Title - Sujet Solid Waste Processing System	
Solicitation No. - N° de l'invitation W8482-178586/A	Amendment No. - N° modif. 003
Client Reference No. - N° de référence du client W8482-178586	Date 2018-10-16
GETS Reference No. - N° de référence de SEAG PW-\$ISM-027-26959	
File No. - N° de dossier 027ism.W8482-178586	CCC No./N° CCC - FMS No./N° VME
Solicitation Closes - L'invitation prend fin at - à 02:00 PM on - le 2018-11-01	
Time Zone Fuseau horaire Eastern Daylight Saving Time EDT	
F.O.B. - F.A.B. Specified Herein - Précisé dans les présentes	
Plant-Usine: <input type="checkbox"/> Destination: <input type="checkbox"/> Other-Autre: <input checked="" type="checkbox"/>	
Address Enquiries to: - Adresser toutes questions à: Beaumier, Julie	Buyer Id - Id de l'acheteur 027ism
Telephone No. - N° de téléphone (613) 851-9981 ()	FAX No. - N° de FAX () -
Destination - of Goods, Services, and Construction: Destination - des biens, services et construction:

AMENDMENT 003

This amendment 003 is raised to correct the numbering in the Statement of Work (in the French version only) and answer questions from potential bidders during the Bidder's Conference and Site Visit or other questions received

Figure 1- Ventilation Details Upper (Mezzanine) and Lower Level Solid Waste Handling Compartment

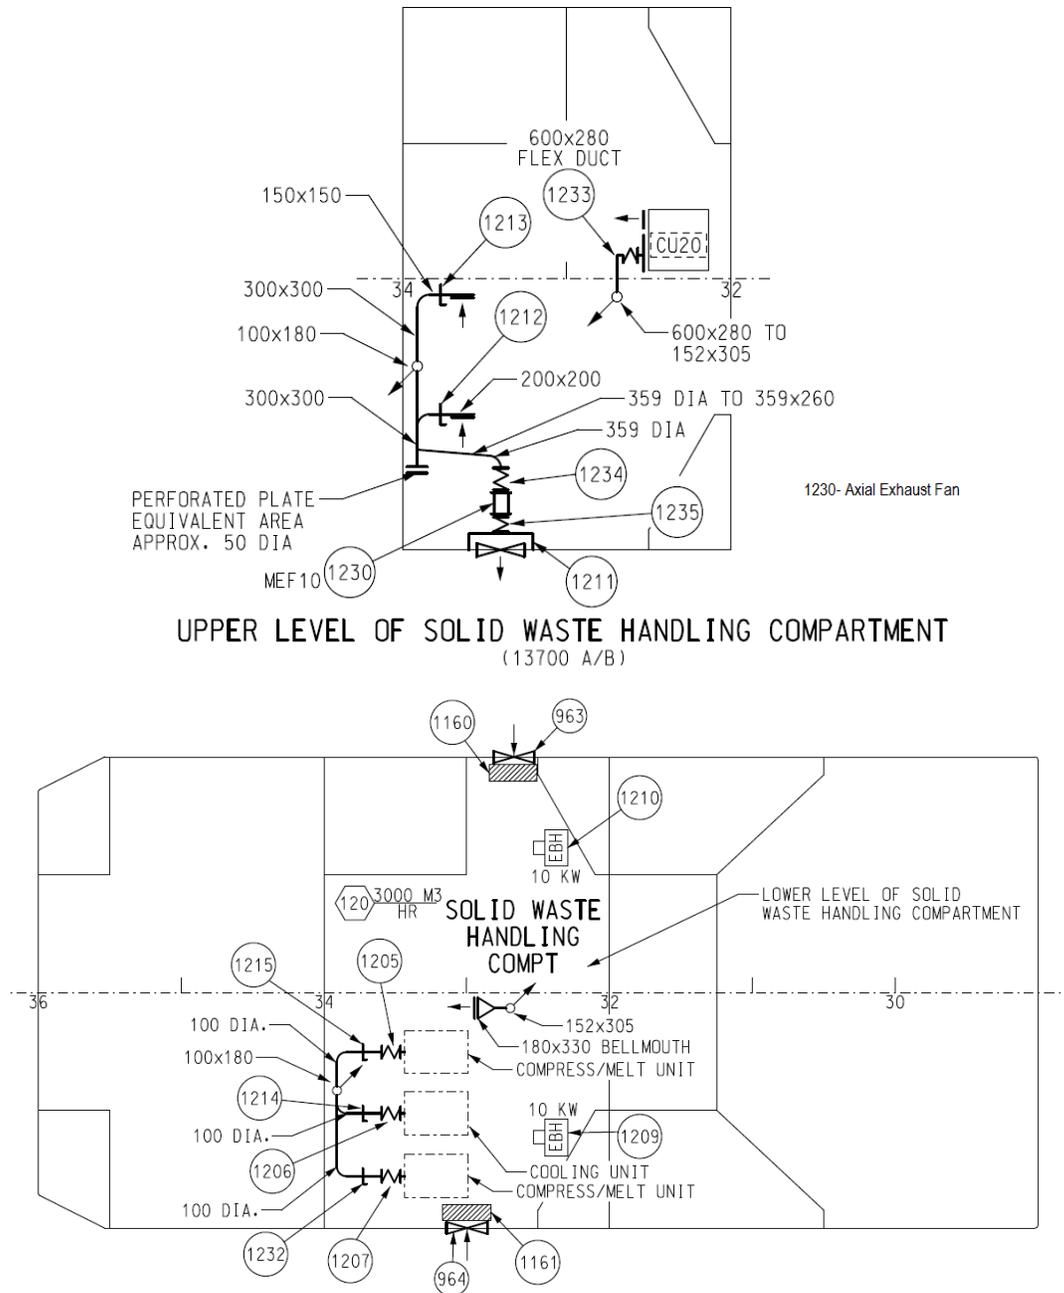
Q18: Where does the ventilation trunking on the starboard side of the mezzanine go?

A18: Reference Figure 1 below for ventilation information.
